Draft Evaluation of Flood Peaks Estimated by USGS

Skagit River Flood Damage Reduction and Ecosystem
Restoration Project Feasibility Study
Skagit County Public Works Department

Pacific International Engineering

November 16, 2004

Figure 1 Stage-discharge rating curve for the Skagit River near Concrete
 (Provided by U.S. Geological Survey, May 2004)

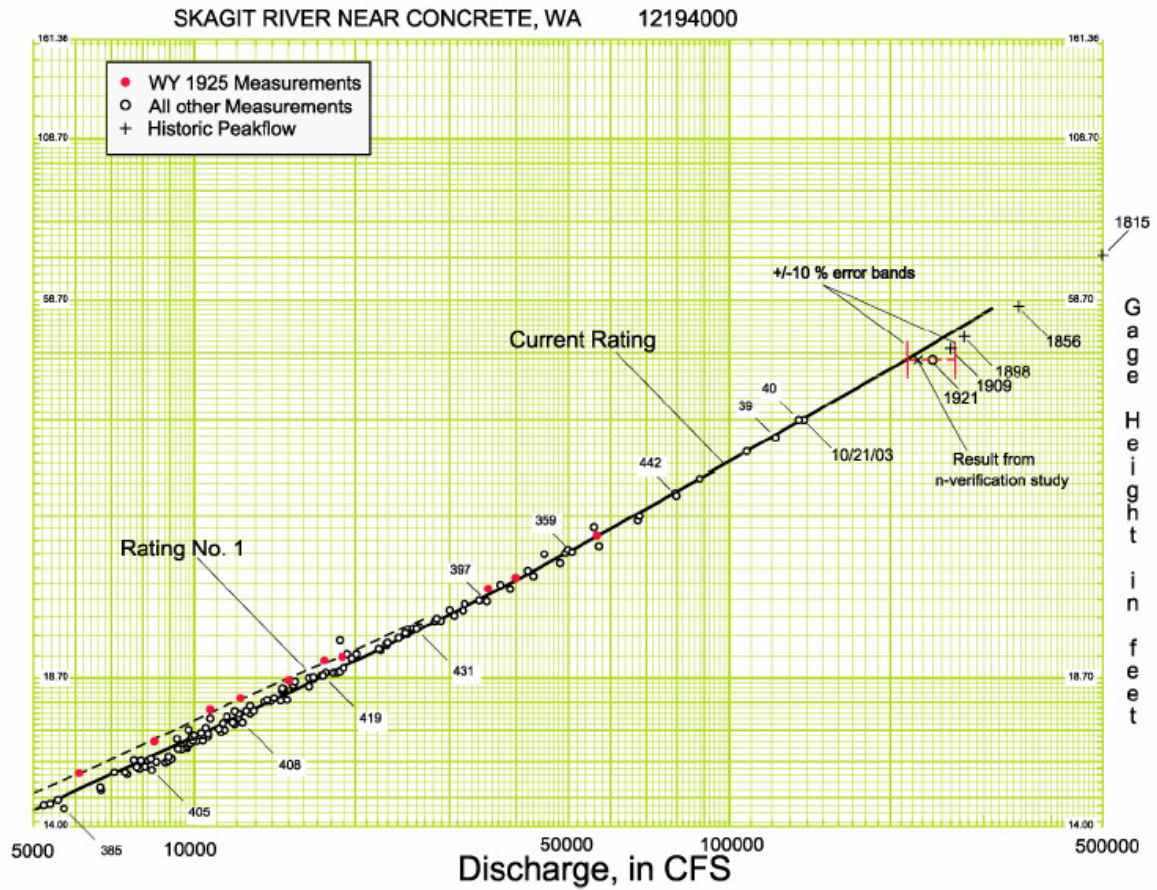
The 1950 review recommended downward revision of the historic flood peak values based on logarithmic extension of the rating curve. As shown in Figure 1, Stewart's measurements for the 1897, 1909, 1917, and 1921 peak flows fall well to the right of the logarithmic rating curve extension. The authors of the 1950 review acknowledged that the curve could bend to the right at the upper end because of overflow on the right bank, but noted that at the time Stewart made his calculations, the overflow area was heavily timbered and would have carried little water. It was recommended that the peak flow estimate for the 1921 event be revised downward from 240,000 cfs to 210,000 cfs. Similar downward revisions were recommended for the 1897, 1909, and 1917 flood peaks.

Figure 4 Rating curves of the Skagit River near Concrete (RM 54.15)

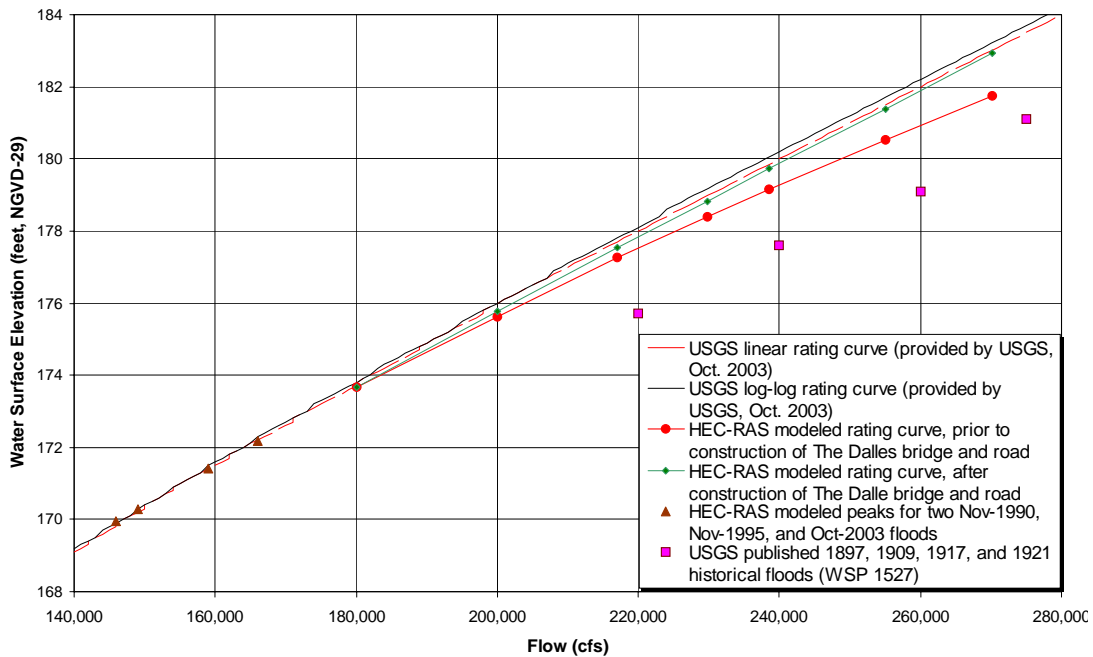
Figure 4 shows a plot of four high flow rating curves at the Concrete gage (RM 54.15). Two are provided by USGS and based on extension of the USGS-developed rating curve (one by a linear extension and the other by a log-log extension) (U.S. Geological Survey 2003). The other two rating curves are based on the HEC-RAS model run results, one including the secondary channel as a ponding area for water level below El. 190 after The Dalles bridge and road construction in 1952; and the other including the right bank secondary channel as a flow conveyance prior to The Dalles bridge and road construction. As shown in the figure, the HEC-RAS independently-developed first rating curve matches closely with both of the USGS linear and log-log rating curves, representing the existing secondary channel conditions.

estimates based on the calibrated and verified HEC-RAS model discussed above. Figure 4 also shows plotted points of the USGS 1923 estimates for these four historical floods. As shown in Table 3, the estimates based on the HEC-RAS modeled rating curve for the secondary channel conditions prior to 1952 are lower than the USGS 1923 estimates as published in WSP 1527 by 5 to 10 percent. Use of the HEC-RAS-modeled rating curve is considered to be a more accurate method for the historical flood estimates if Stewart’s rated section is exactly at the current gage location (RM 54.15).

Figure 5 Rating curve of the Skagit River near Concrete (RM 54.19)

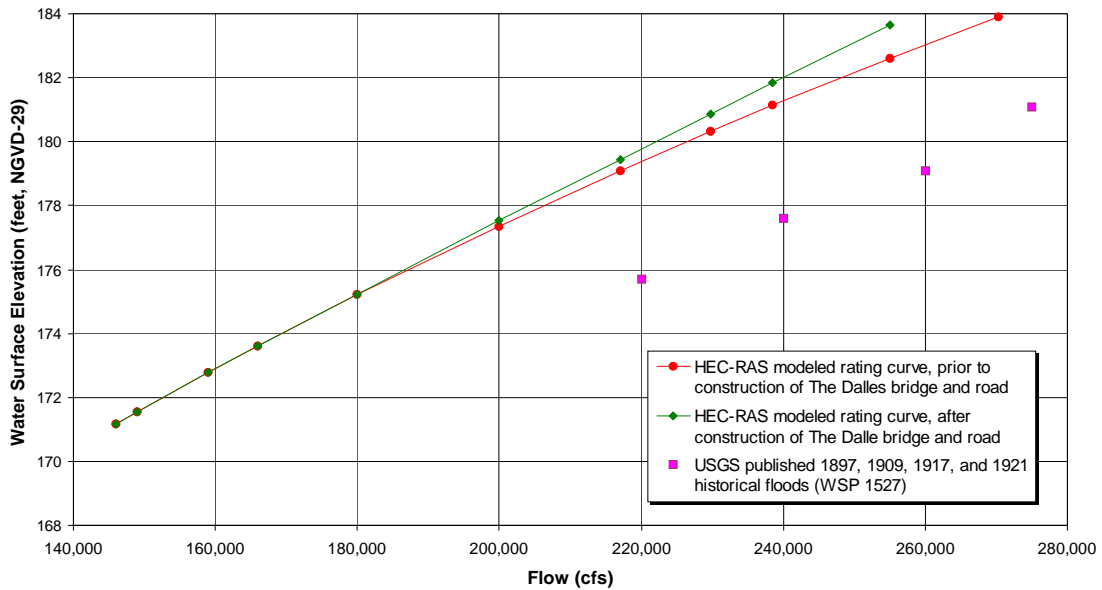
However, if Stewart’s rated section is the “staff gage at site 200 ft upstream” (Flynn 1954), the water surface elevation at this staff gage location (RM 54.19) would be 1.6 to 2.0 ft higher than those at the current gage location (RM 54.15) for the flow range of the 1897, 1909, 1917, and 1931 floods. Figure 5 shows the staff gage rating curve based on the pre-1952 conditions HEC-RAS modeling results presented in Appendix A-4. Table 4 shows the revised flow estimates for these four historical floods, using the USGS published gage heights in WSP 1527 converted to water surface elevations, and using the HEC-RAS modeled rating curve shown in Figure 5. The USGS 1923 estimates are 16 to 20 percent higher than the estimates based on the HEC-RAS modeled rating curve for the pre-1952 conditions.

The existence and accuracy of the original HWM survey data and flow estimates for the 1897, 1909, 1917, and 1921 floods should be confirmed. Given the significant difference that inclusion or exclusion of these data has on the flood frequency analysis, only

the confirmed HWMs and HEC-RAS-modeled rating curve (Figure 5) at RM 54.19 should be used to calculate flood peaks.
